# 435 DEXTER

August 6, 2014  
Design Review  
Recommendation #2  
DPD Project# 3016347

Current 8/6/14 Northeast Corner Perspective View from North

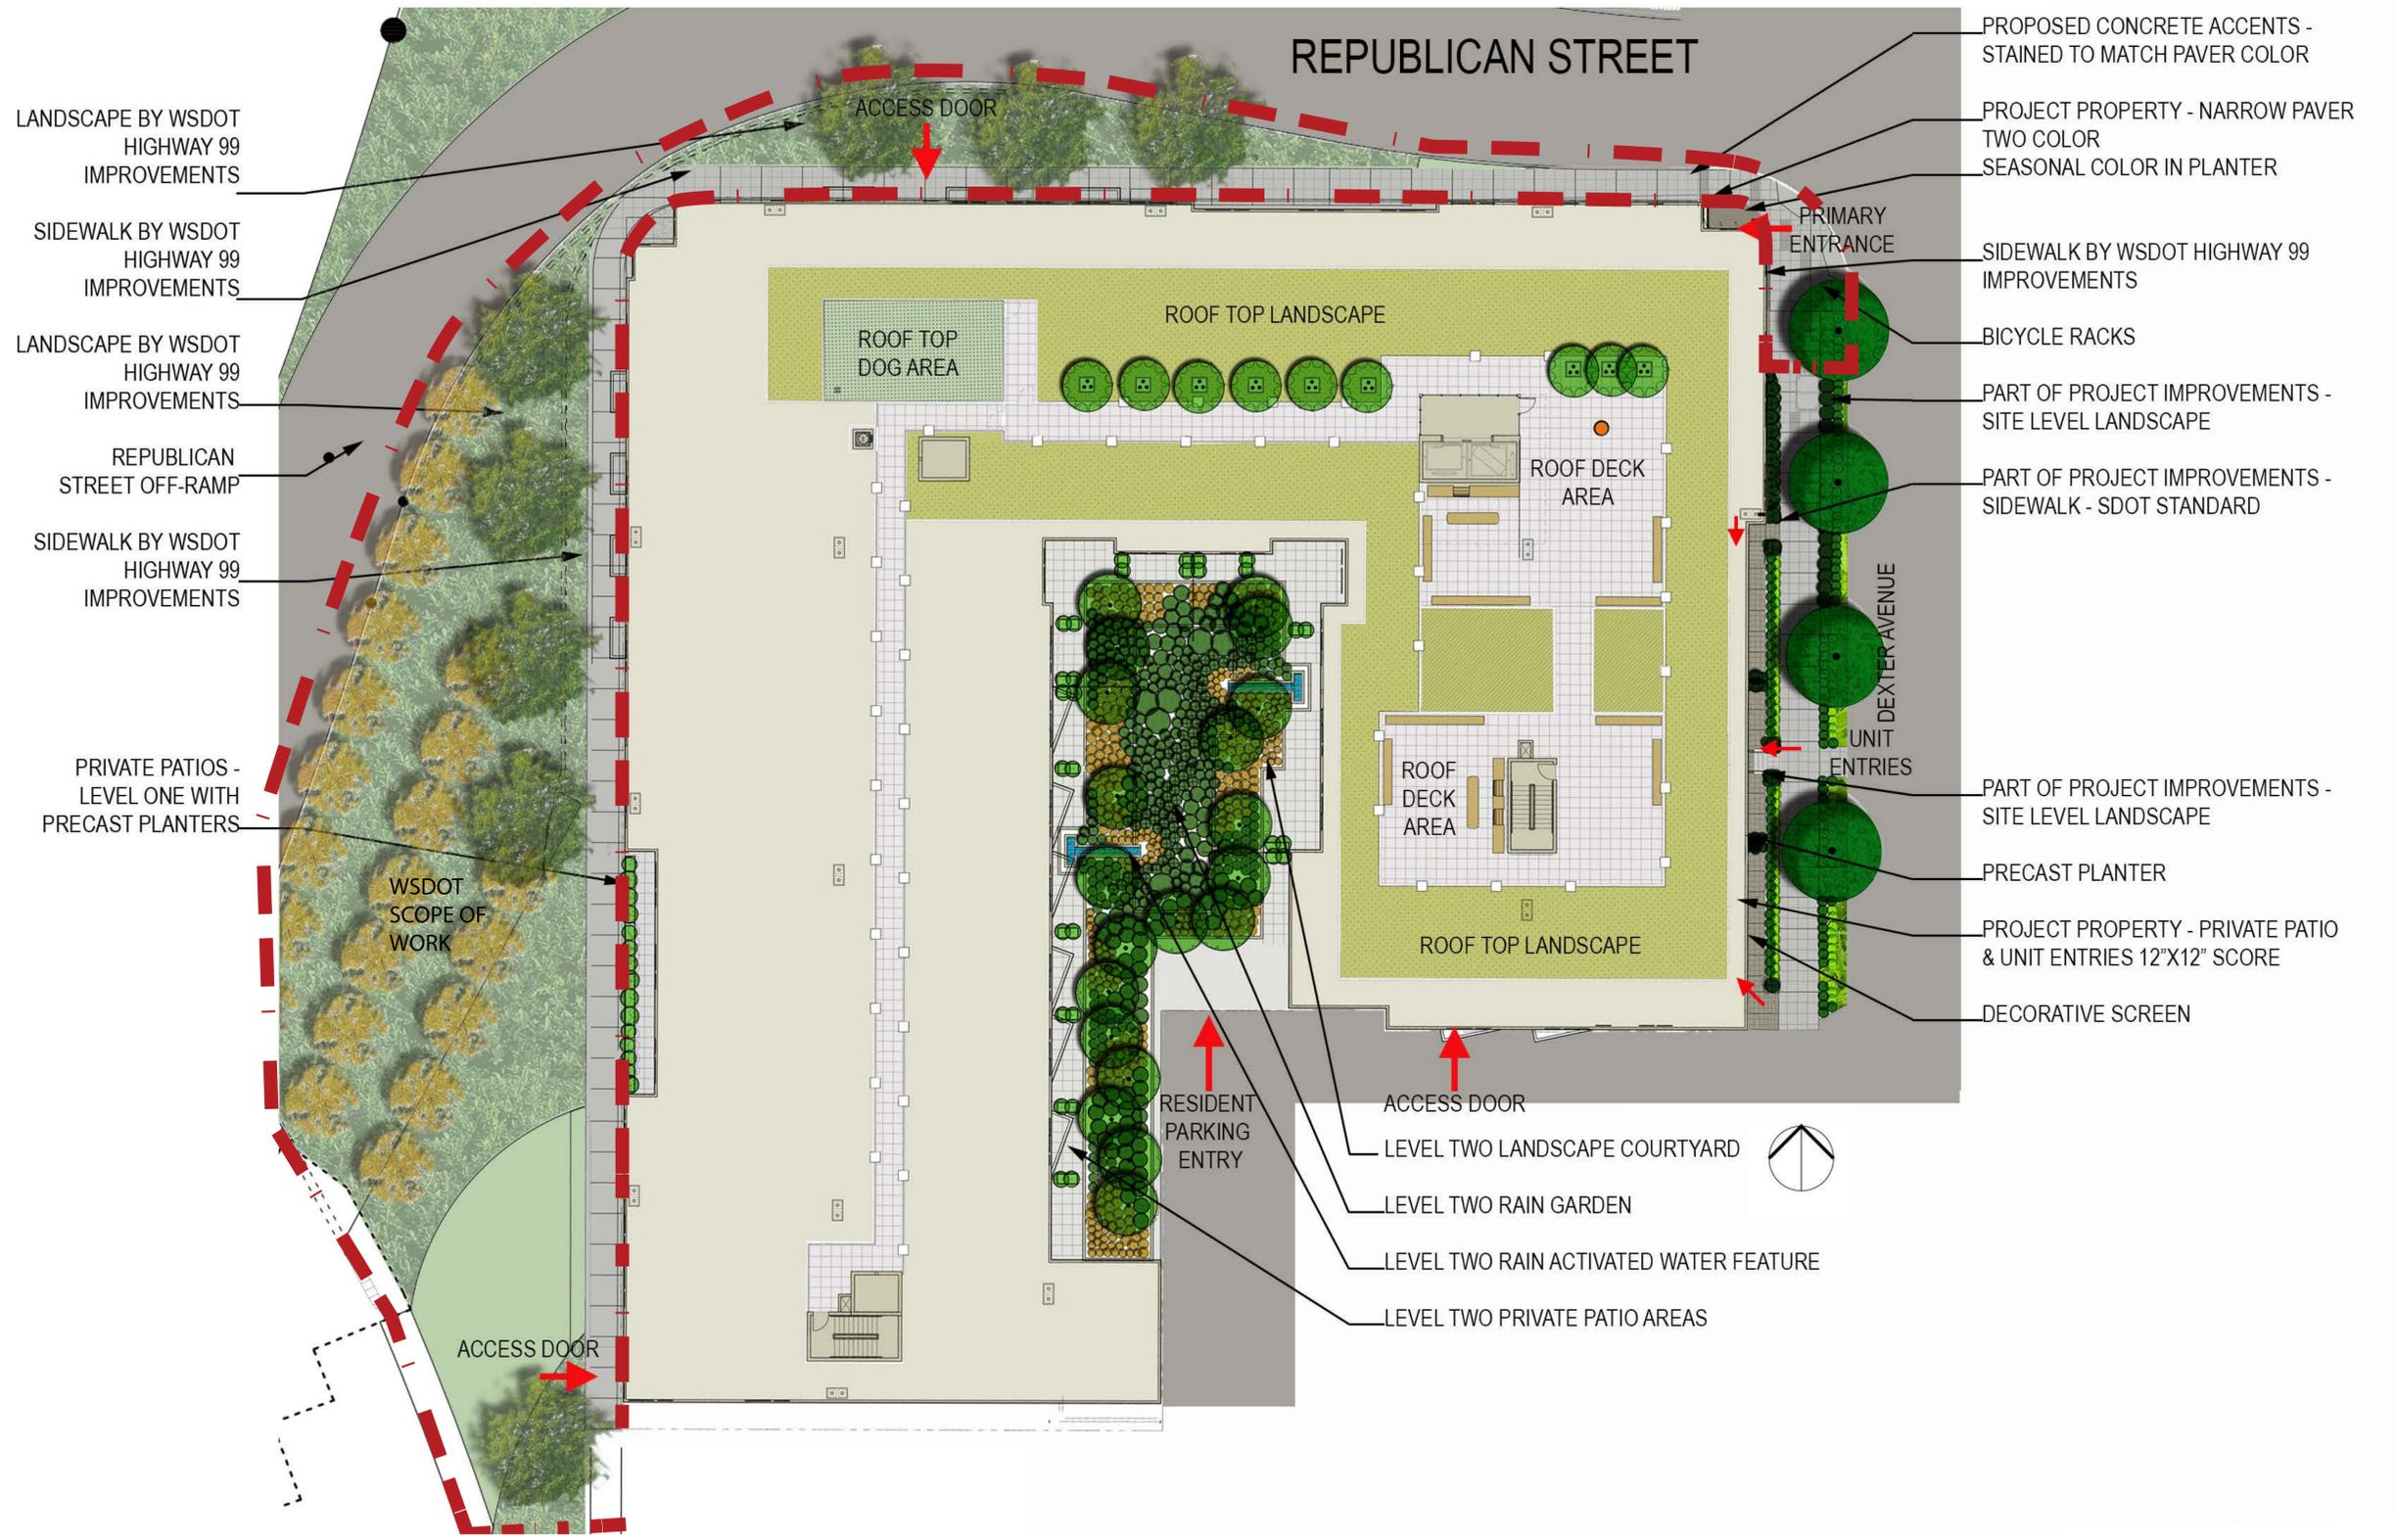
## 1. Northeast Corner: Initial Recommendation

- Primary entry should feature pedestrian-oriented site accessories with enhanced paving and landscaping

# 1. Northeast Corner: Applicant Response

- Street-level at entry now features special paving, bike racks, informal seating, and plantings.

CANOPY, ACCENT COLORS TO EMPHASIZE PRIMARY ENTRY

CONTAINER PLANTING  
INFORMAL SEATING

BIKE RACKS

# LANDSCAPE SITE PLAN

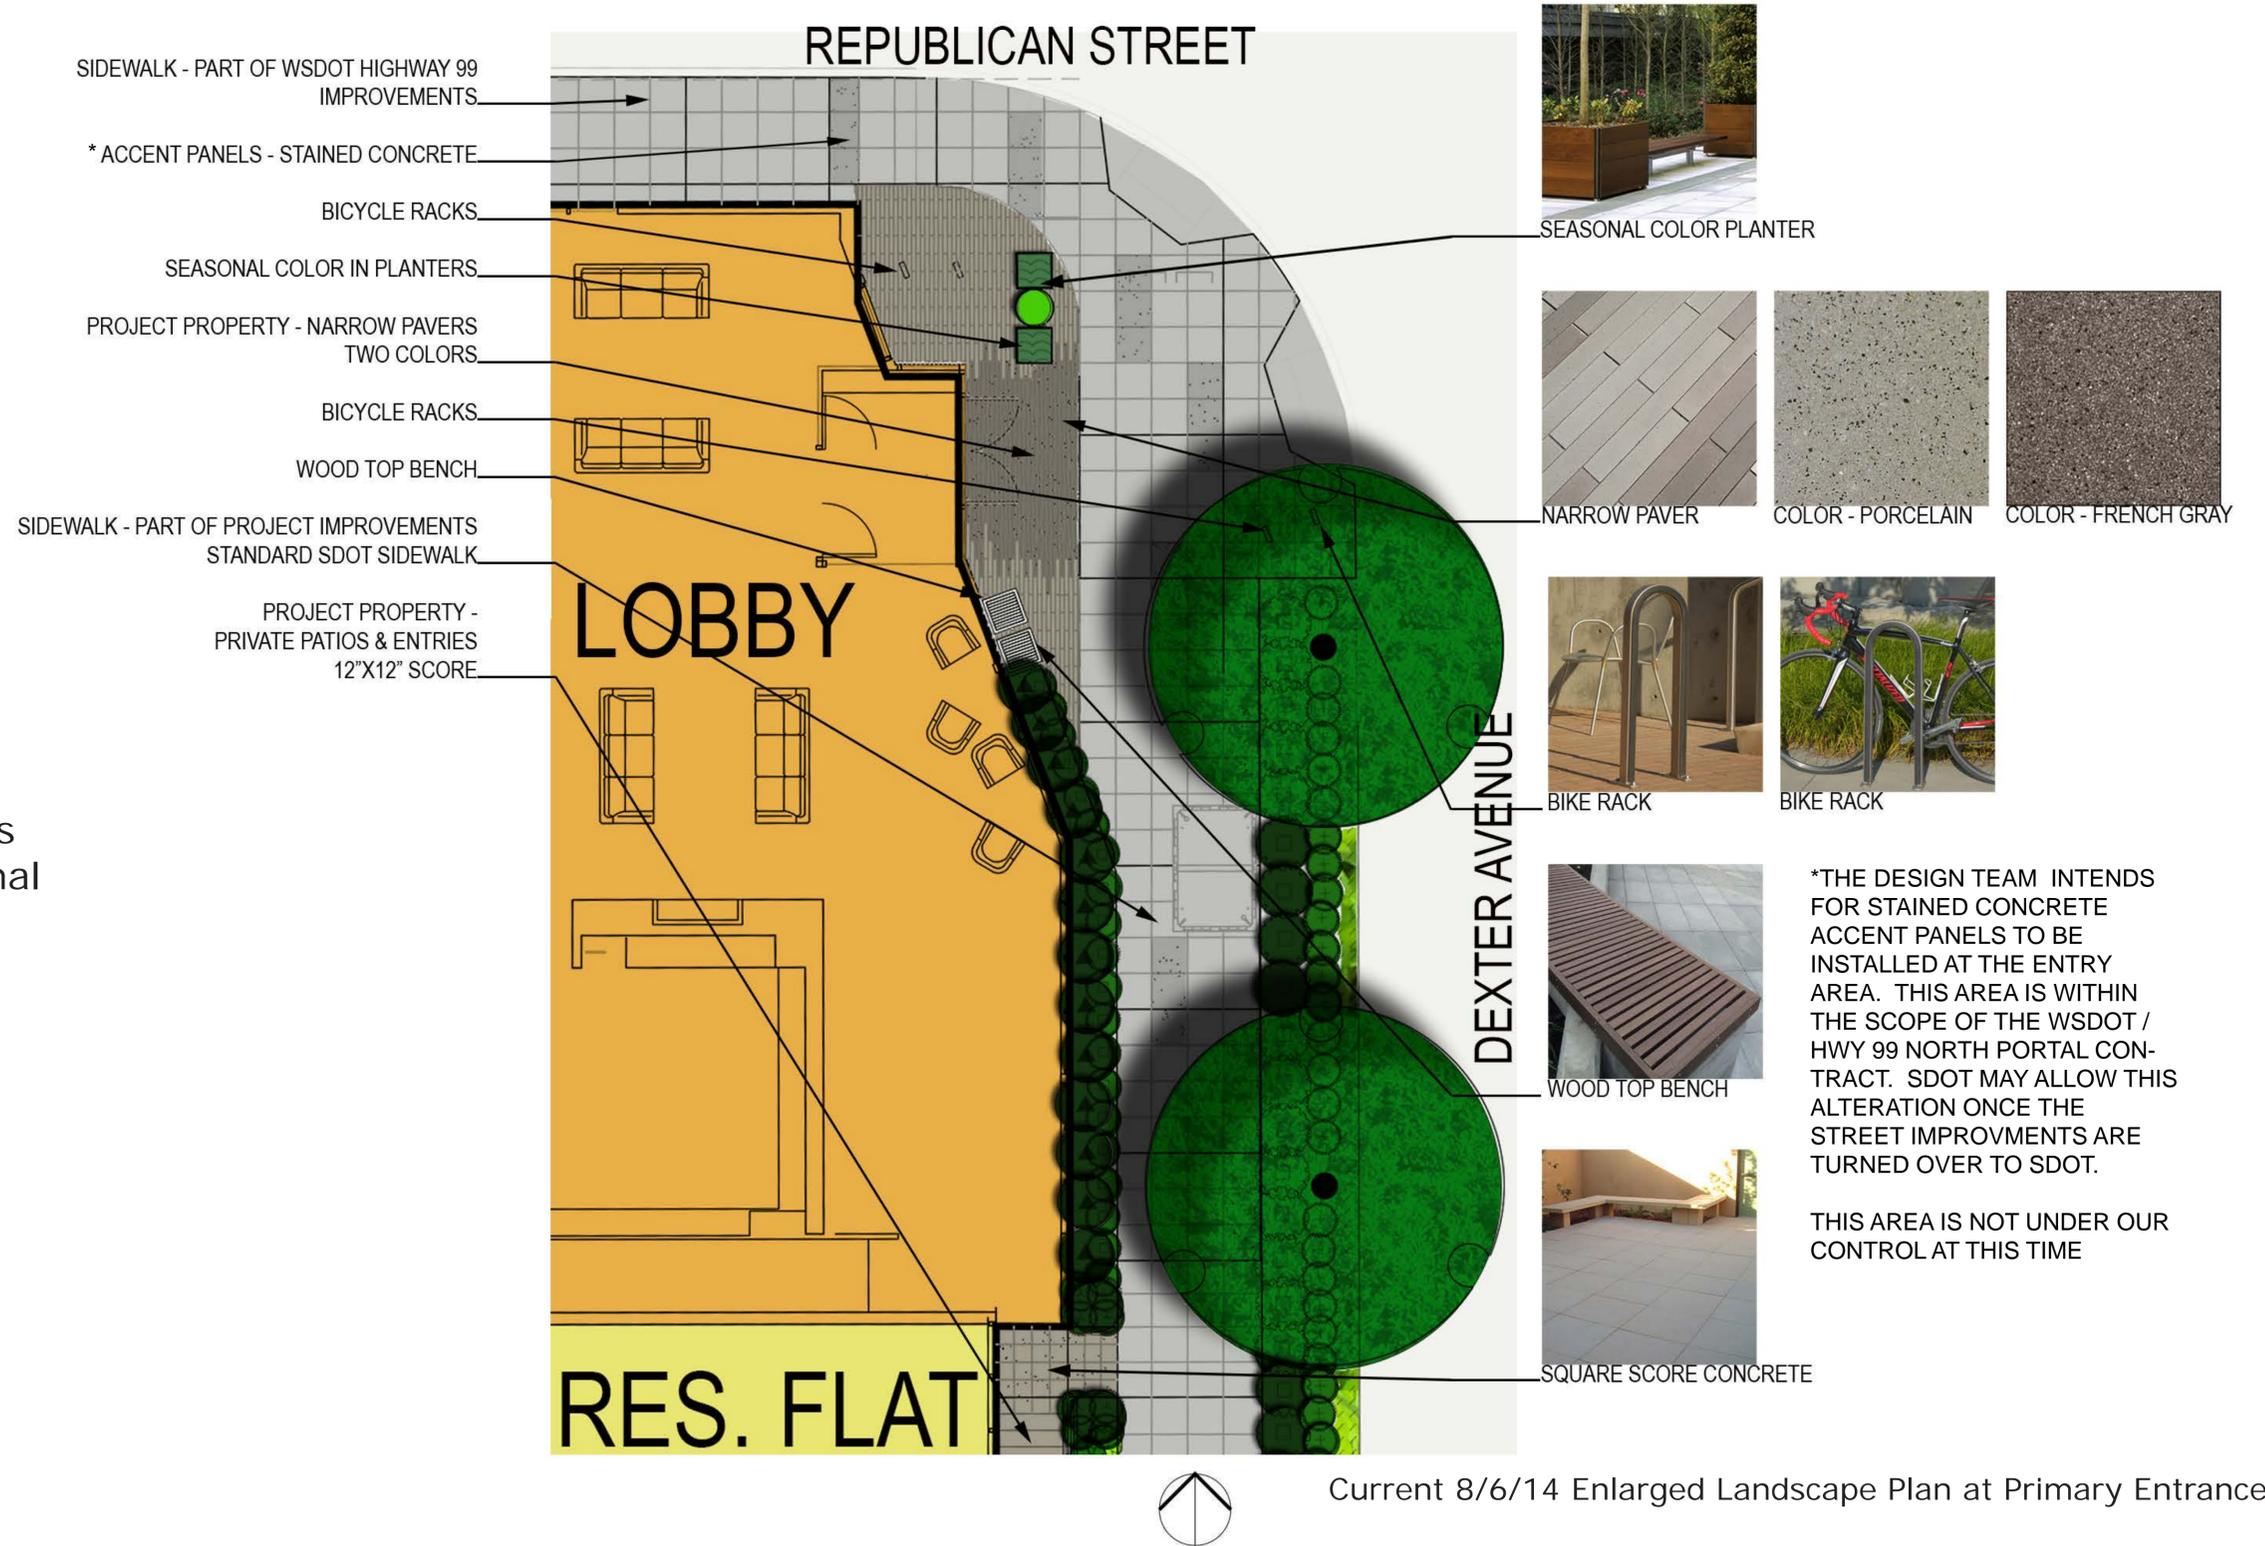
**1. Northeast Corner:  
Initial Recommendation**

- Landscape should create hierarchy between primary entry and individual street-level residences

- Street-level at entry now features special paving, bike racks, informal seating, and plantings.

- Plant associations developed to distinguish primary entry and individual street-level residences

PAVING HEIRARCHY DIAGRAM

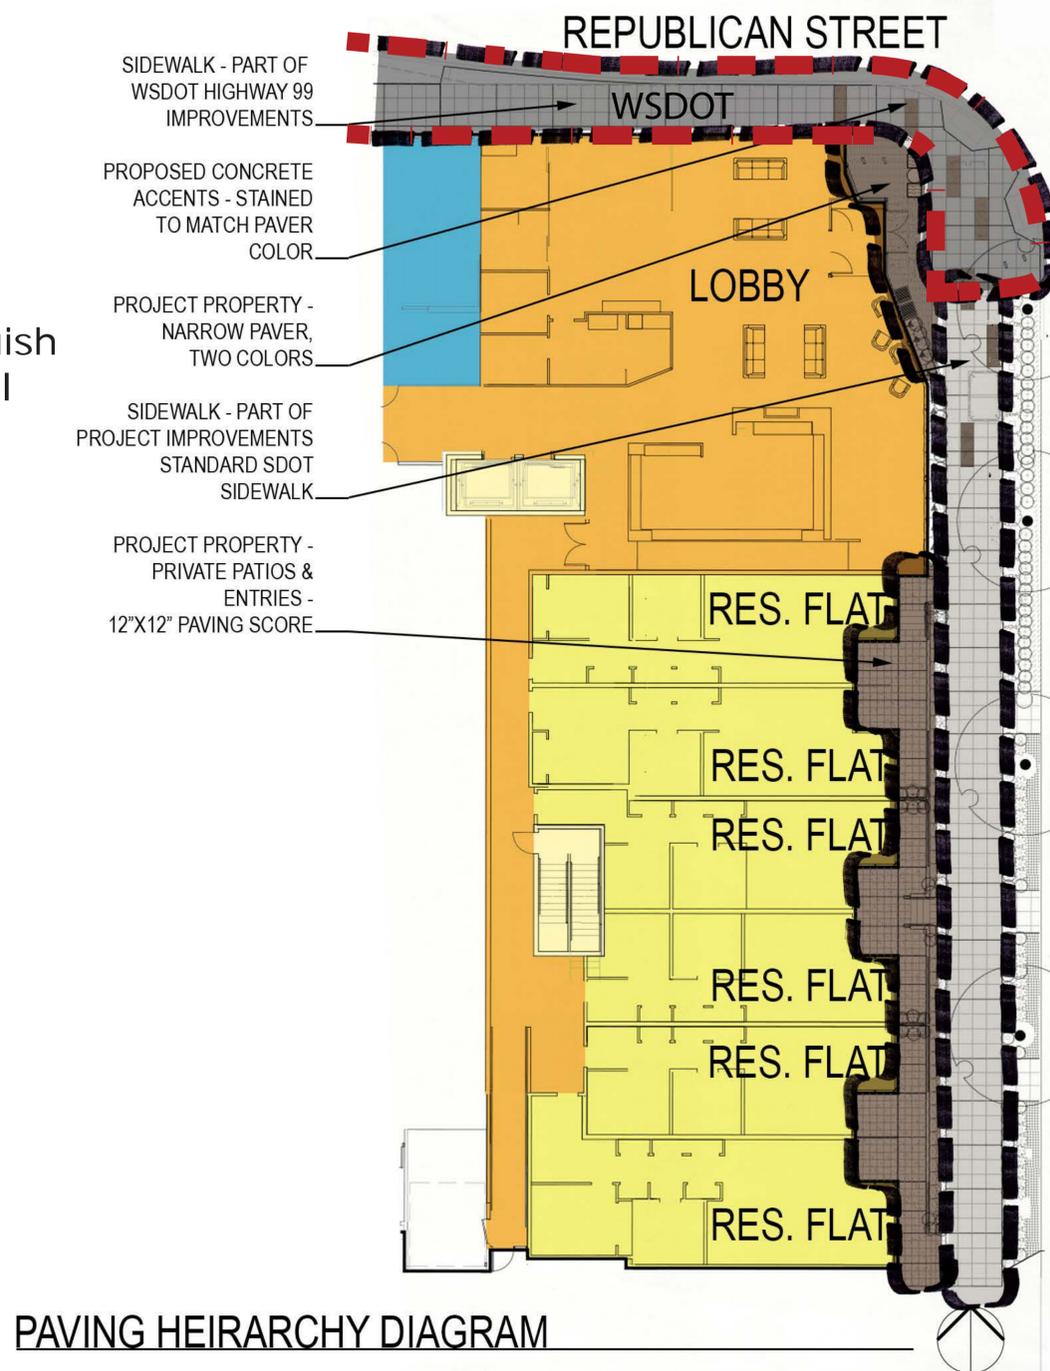
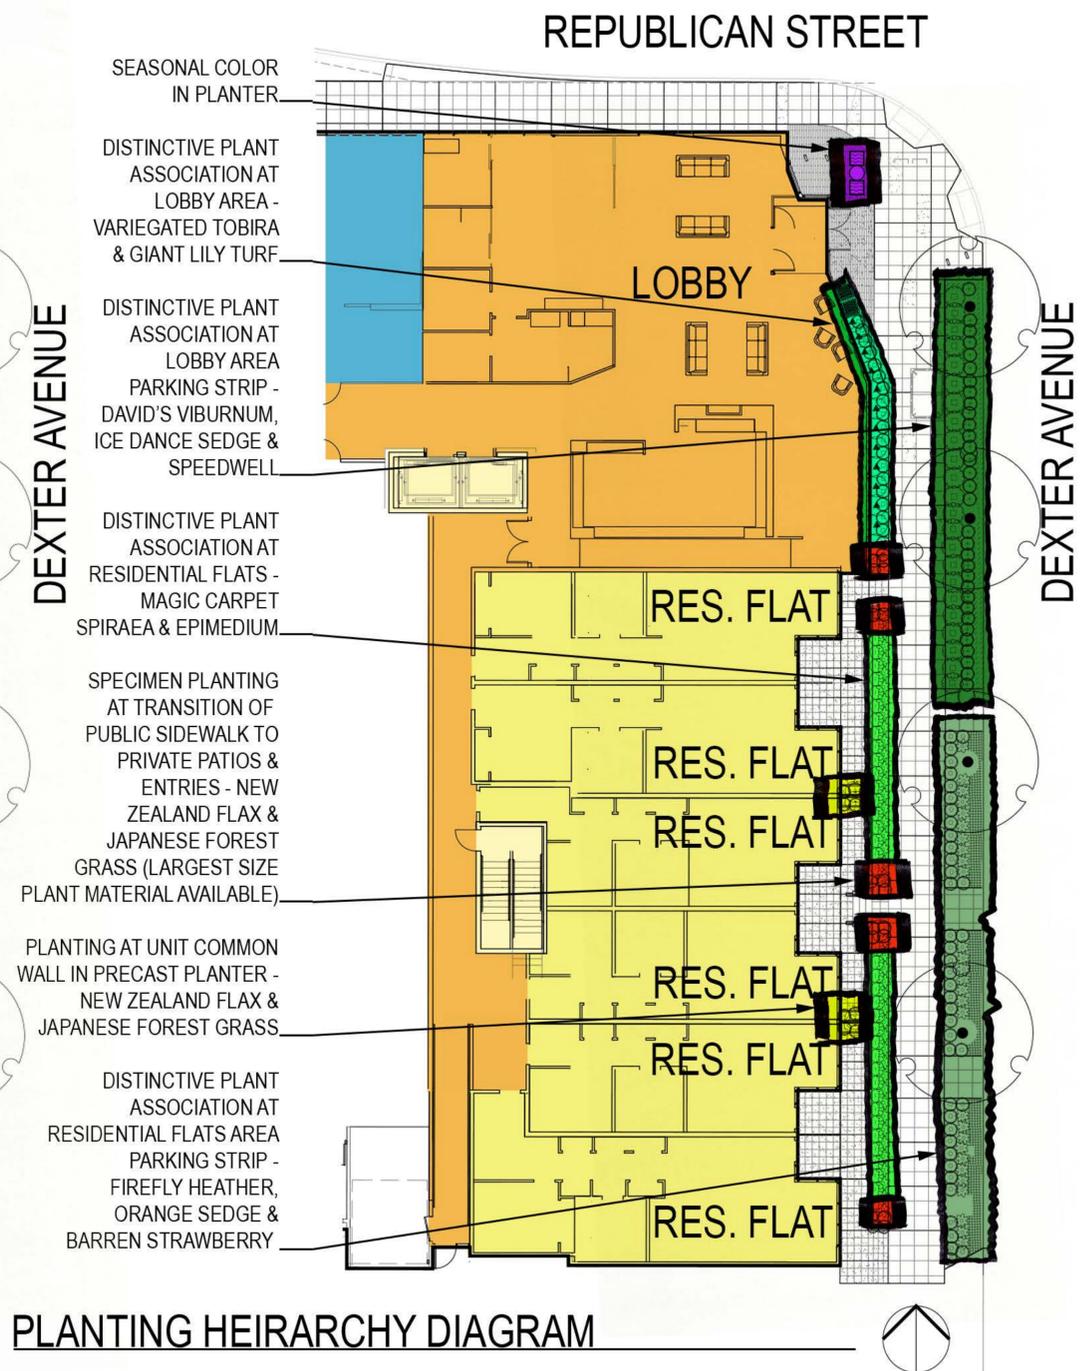
**3. Dexter Ave N:  
Initial Recommendation**

- Plant materials need to be taller and more varied to soften edge between sidewalk and patios

**Applicant Response**

- Plantings developed with more variety and to soften edge
- Speciman plantings taller to mark individual residential entries
- Plantings in precast planters rise above on-grade plantings

Dexter Street Section at Residential Units

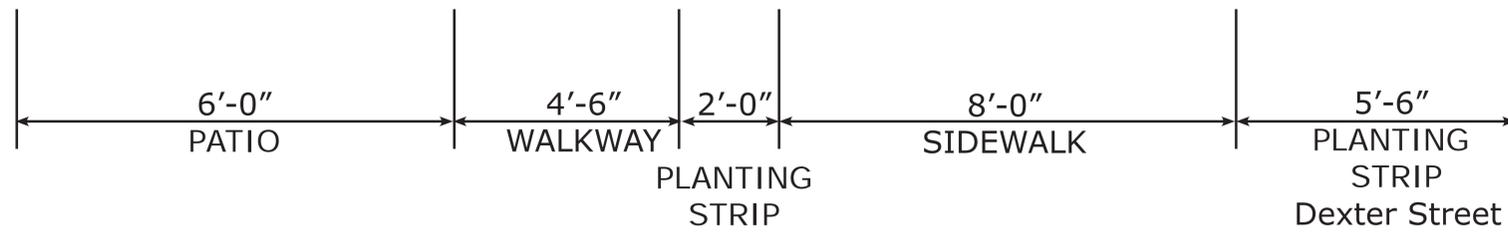
#### **Initial Recommendation**

- Lower privacy screens for more street visibility

- Privacy screens between units lowered to 42" tall.

PRIVACY SCREEN LOWERED
